Status: Y N U**Seismic Walkdown Checklist (SWC)**Equipment ID No. 1-1805-53-015 Equip. Class¹² ZEquipment Description 480V Switchgear 1AD15Location: Bldg. Aux/41 Floor El. 119'-3" Room, Area RD105

Seismic Walkdown Checklist (SWC)

[Signature] / Justo S. Chacon 10/1/12

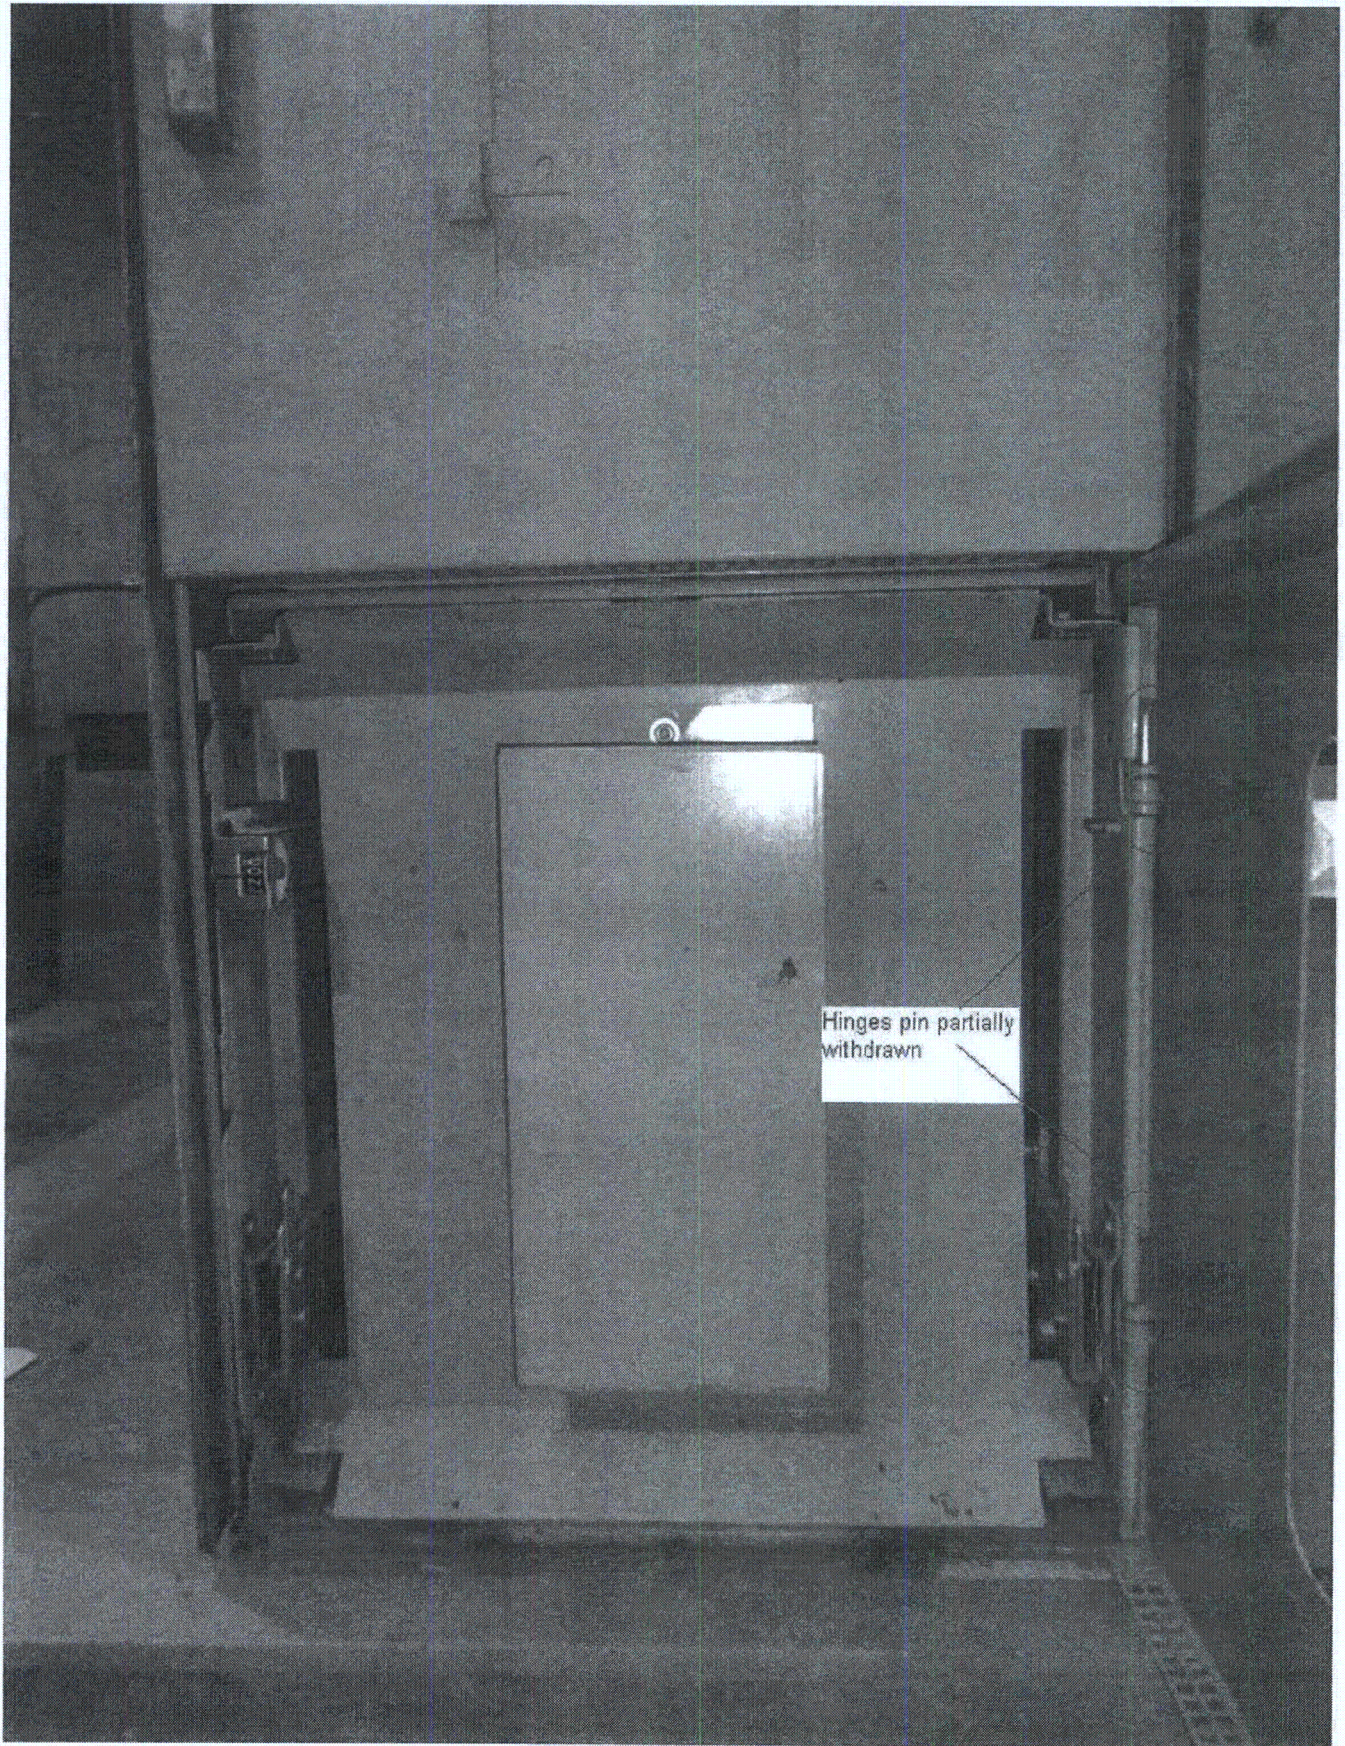
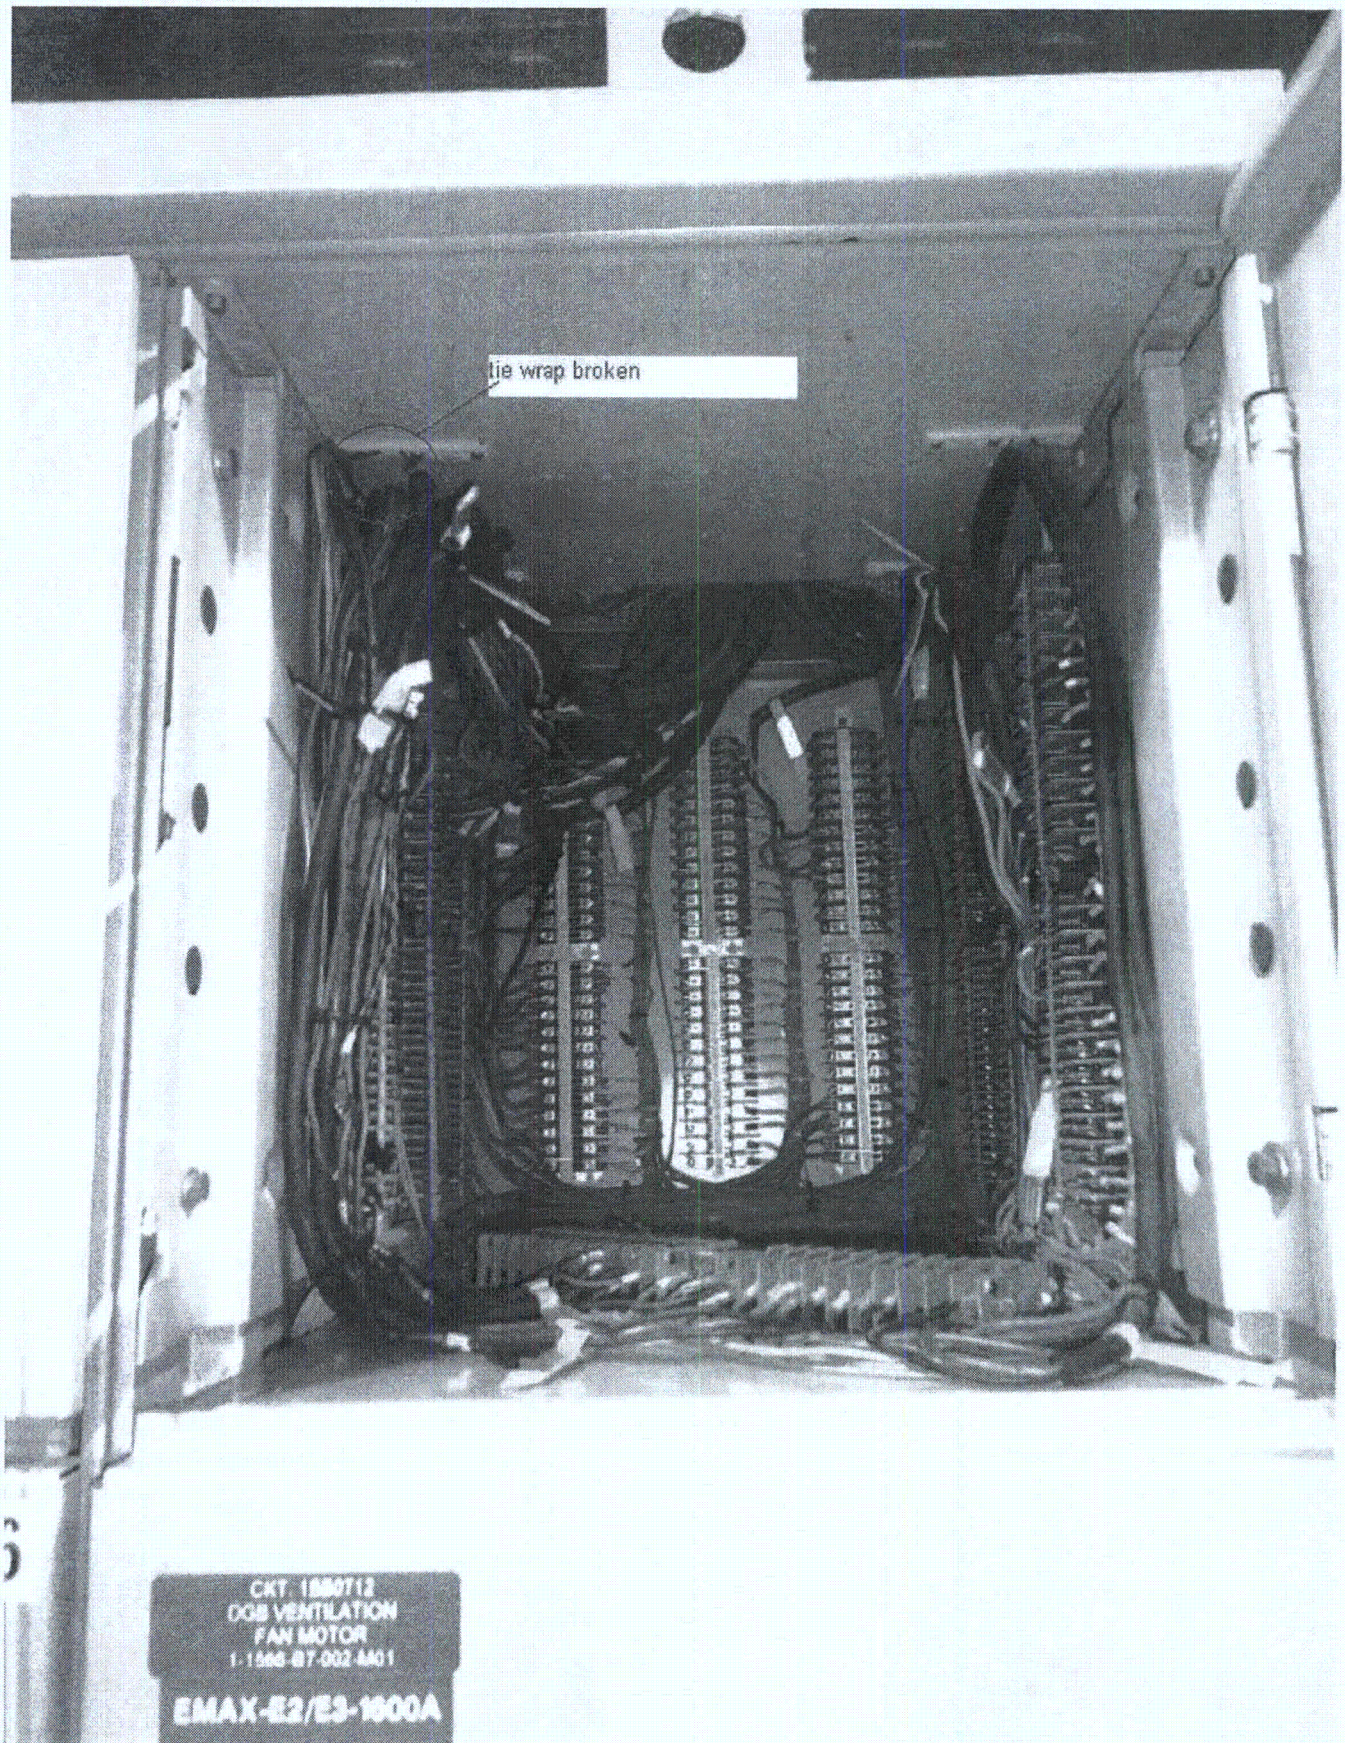
- ① Found 1 inter connecting fastener missing which connects cabinet's bays 1B0710 and 1B0714. Condition Report 527135 has been generated to evaluate seismic adequacy.
- ② Found 1 tie wrap broken used to support a cable bundle in bay 11. This is not a seismic or vulnerability concern. Ref. CR 528379
- ③ Found 2 (two) door hinge pins partially with drawn on bay 18. This is not a seismic or vulnerability concern. CR 528379
